CHANNEL 1 INPUT AMPLIFIER

Type 422 | **PRODUCT MODIFICATION INDEX**

FIG. 2

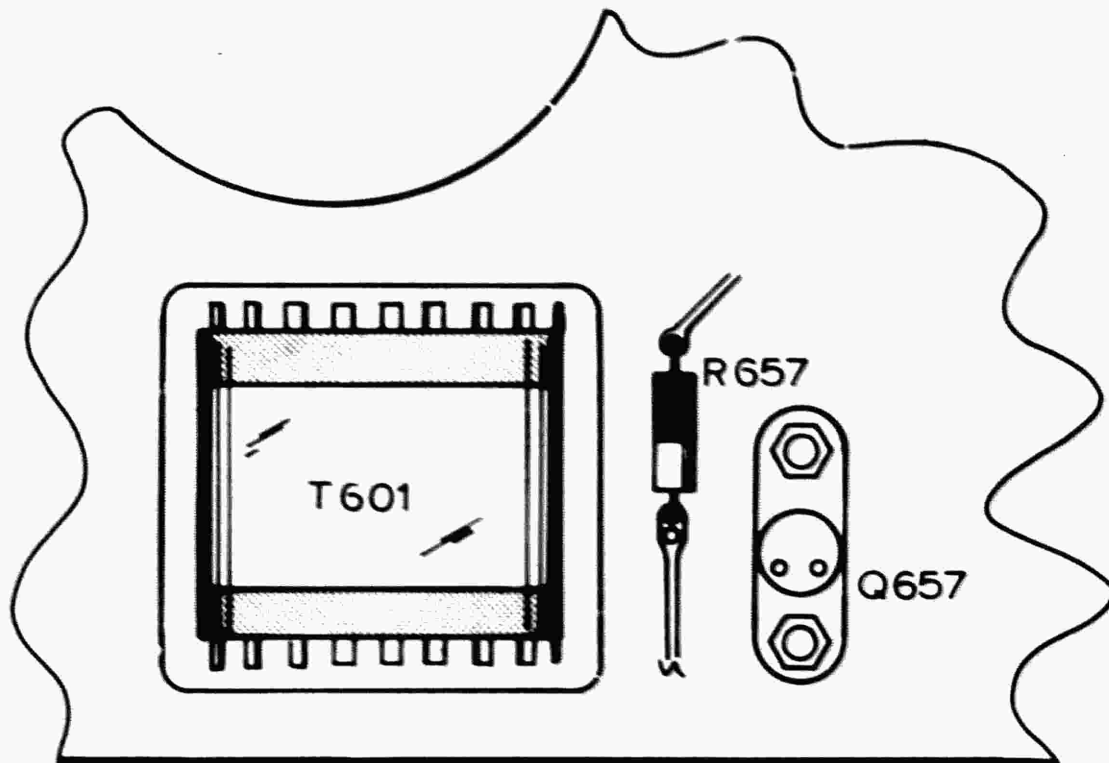
( ) 5. Replace R657 located on the AC Power Supply circuit board between T601 and Q657 with a 15Ω 1W 5% resistor from the kit. See Fig. 2.

FIG. 1

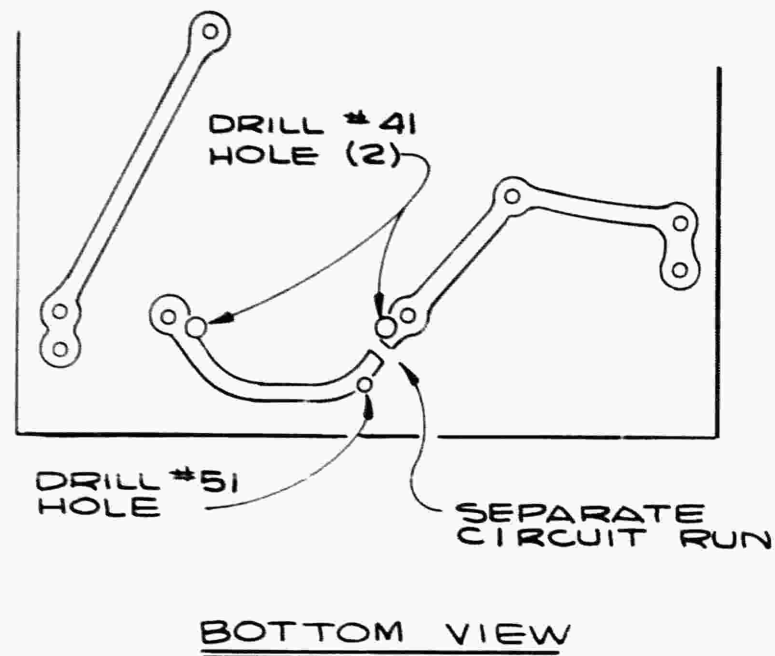
- a) Remove the HV Power Supply assembly from the instrument.
  - b) Remove the metal shield and the plastic lid from the Power Supply assembly.
- NOTE: For future reference, observe how the HV circuit boards and HV transformer are mounted in the plastic container.
- c) Remove the HV circuit boards and HV transformer from the plastic container.
  - d) Cut and remove approximately 3/16" of the circuit run on the High Voltage Regulation circuit board as shown in Fig. 1.
  - e) Drill two holes, using a #41 drill, in the location on the circuit board as shown in Fig. 1.

FIG. 2

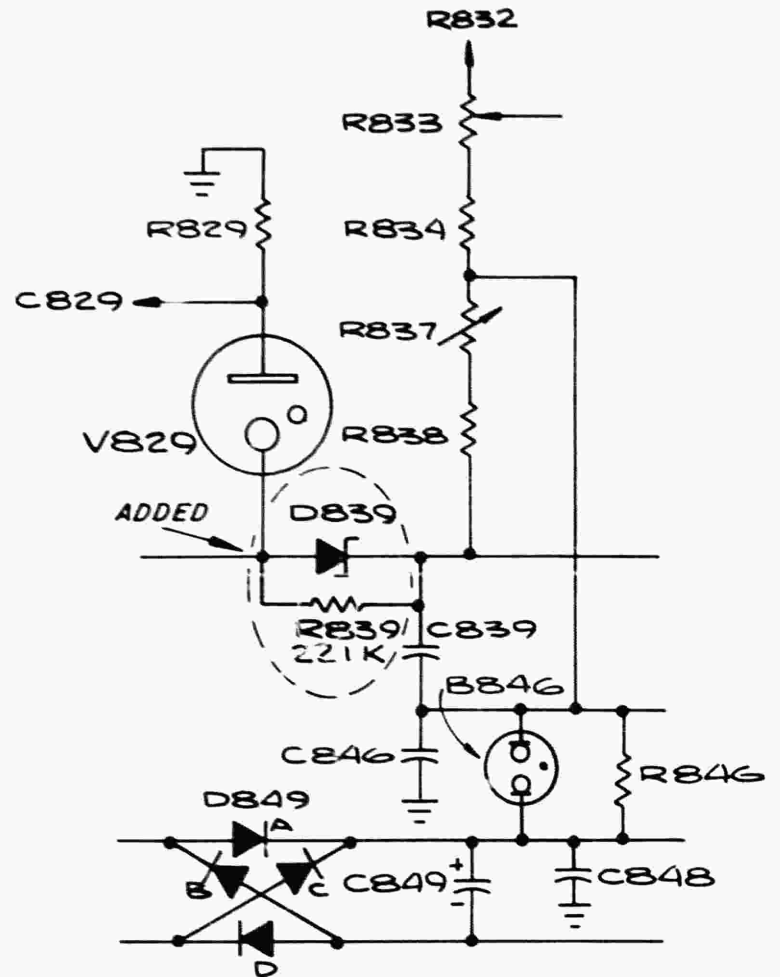
- j) Unsolder the two white-orange wires from "Board Reference A". See Fig. 2.
- k) Use an ohmmeter to determine which of the white-orange wires goes to pin 3 of the CRT socket and solder this wire into the rivet installed in step i.

- l) Resolder the remaining white-orange wire to the "Board Reference A" as shown in Fig. 2.
- m) Perform steps a through c in reverse order.

FIG. 1 OLD ASSEMBLY, PN 670-0411-00

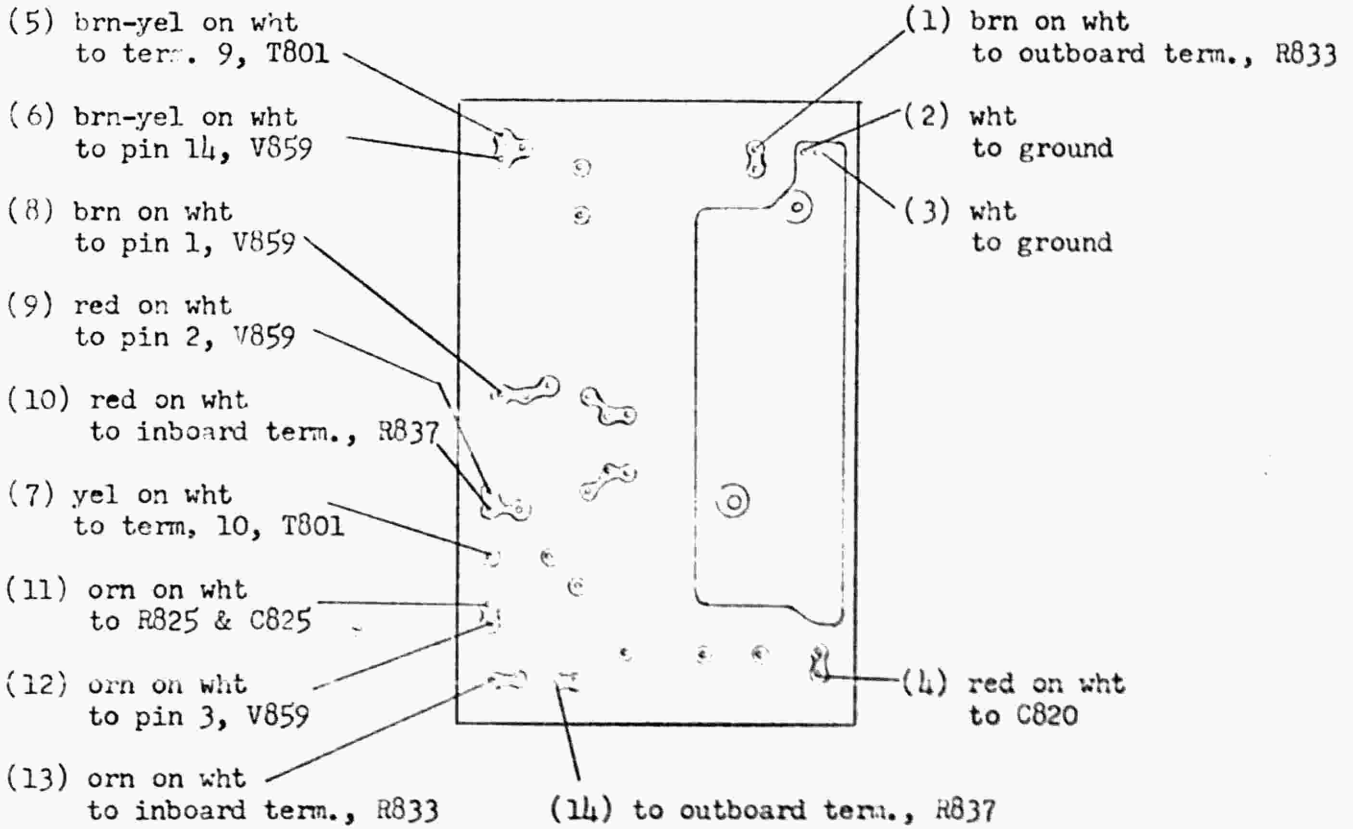
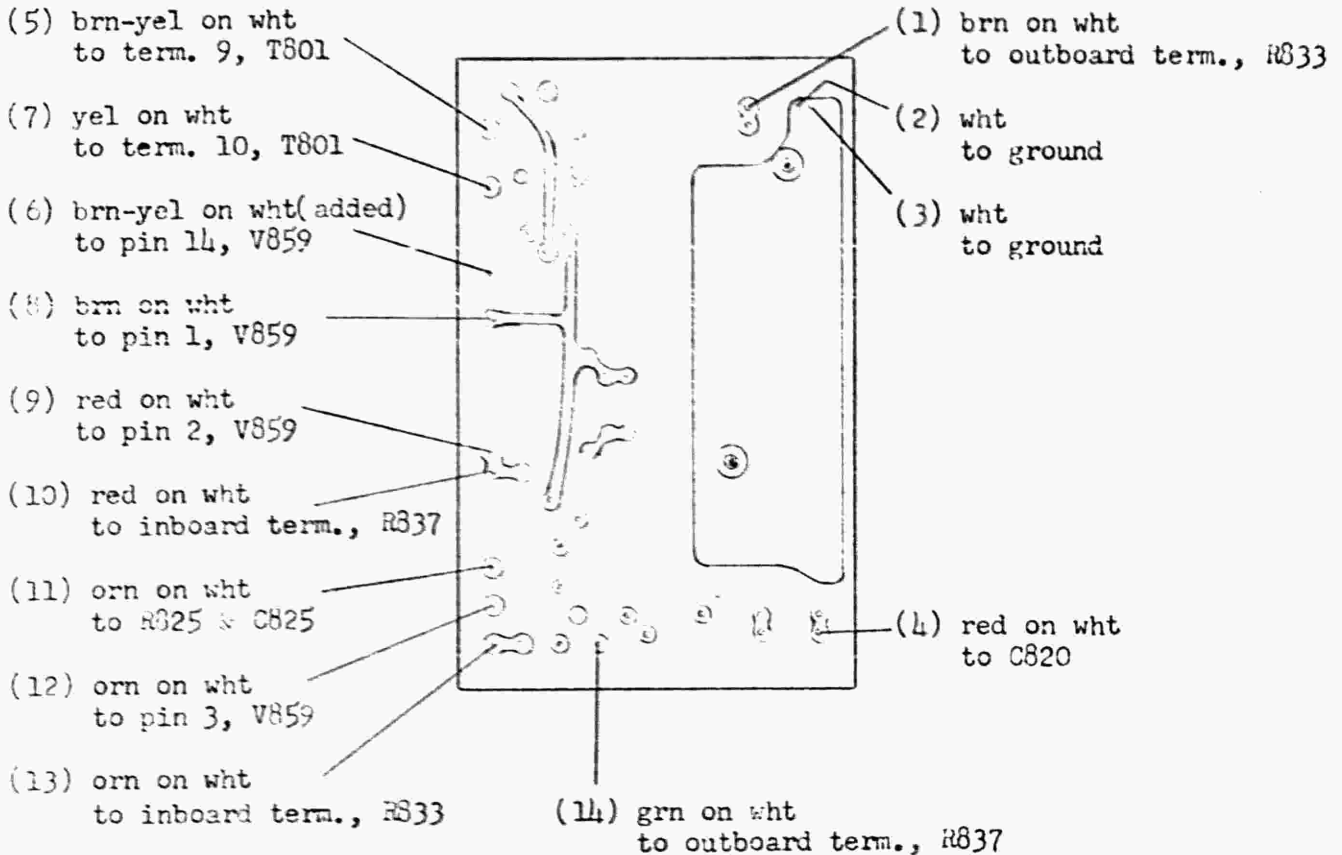
FIG. 2 NEW ASSEMBLY, PN 670-0411-01
